## Agenda Item #: 2 SUB-002702-2023

Morris Landing Subdivision

- Subdivision approval to create one (1) legal lot of record from one (1) metes and bounds parcel.

# SITE PLAN

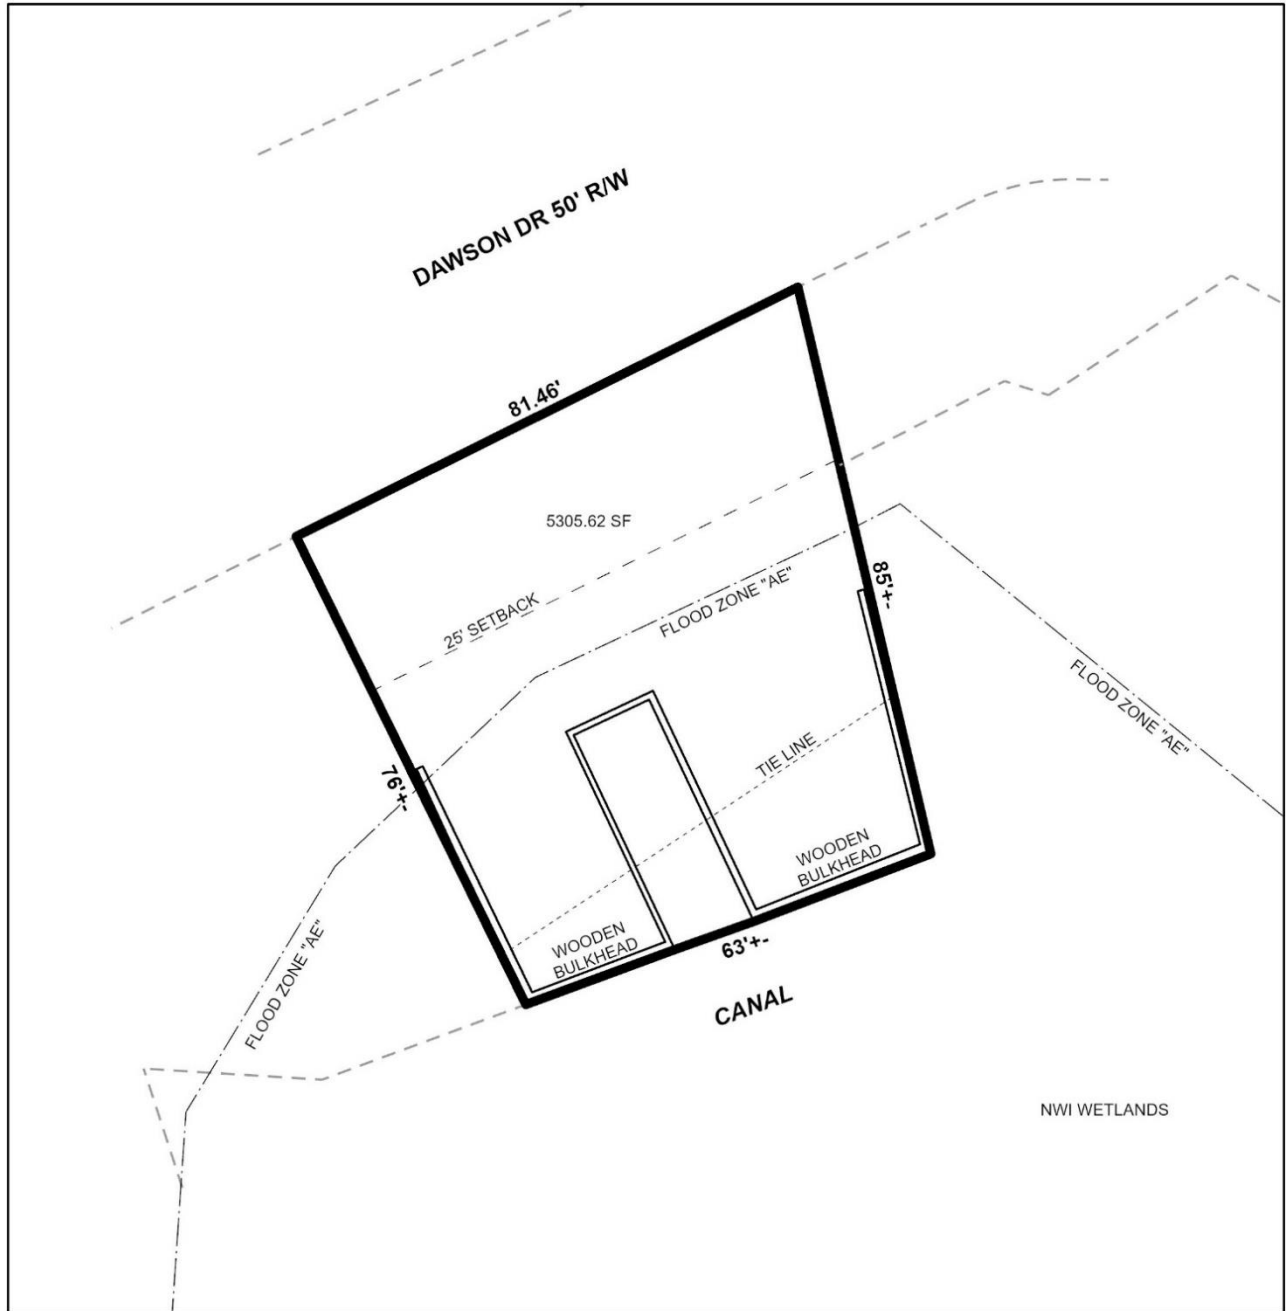
The site has frontage on Dawson Drive, a minor street without curb and gutter, requiring a 60-foot right-of-way. The Preliminary Plat depicts a 50-foot right-of-way; therefore, dedication sufficient to provide 30 feet from the centerline of Dawson Drive should be required. It should be noted that dedication of right-of-way would increase the degree of noncompliance by further reducing the lot size.

A 25-foot front yard setback is illustrated along Dawson Drive, in compliance with Section 64-2.5.E. of the Unified Development Code. Due to the dedication of additional right-of-way, the front setback would shift, and as such, should be adjusted to accommodate required dedication, if approved.

The Preliminary Plat depicts a lot size of 5,305± square feet which does not meet the minimum 7,200 square-foot size requirement of Article 2, Section 64-2.5.E. of the Unified Development Code for lots served by public water and sanitary sewer in an R-1, Single-Family Residential Suburban District. The lot size is provided in square feet and acres on the Preliminary Plat. If approved, this information should be retained on the Final Plat, adjusted for dedication; or a table should be furnished on the Final Plat providing the same information, adjusted for dedication.

Lots along Dawson Drive vary in areas ranging from 5,564 square feet to 47,800 square feet. As proposed, with dedication, the lot would be further reduced in size from the 5,305± square feet being proposed, well below any other lot along Dawson Drive. If approved, a waiver of Section 6.C.2.(a)(1) will be required to allow the reduced lot size.

The Preliminary Plat does not illustrate any easements, however, if approved, a note should be required on the Final Plat stating that no structure may be constructed or placed within any easement without the permission of the easement holder.

1. Revision of the Final Plat to depict dedication sufficient to provide 30 feet from the centerline of Dawson Drive;
2. Retention of the setback as shown on the preliminary plat, adjusted for dedication;
3. Retention of the lot sizes in both square feet and acres, or the furnishing of a table on the Final Plat providing the same information, adjusted for dedication;
4. Placement of a note on the Final Plat stating that no structure may be constructed or placed within any easement without the permission of the easement holder;
5. Compliance with all Engineering comments noted in this staff report;
6. Placement of a note on the Final Plat stating all Traffic Engineering comments noted in this staff report;
7. Compliance with all Urban Forestry comments noted in this staff report; and,
8. Compliance with all Fire Department comments noted in this staff report.
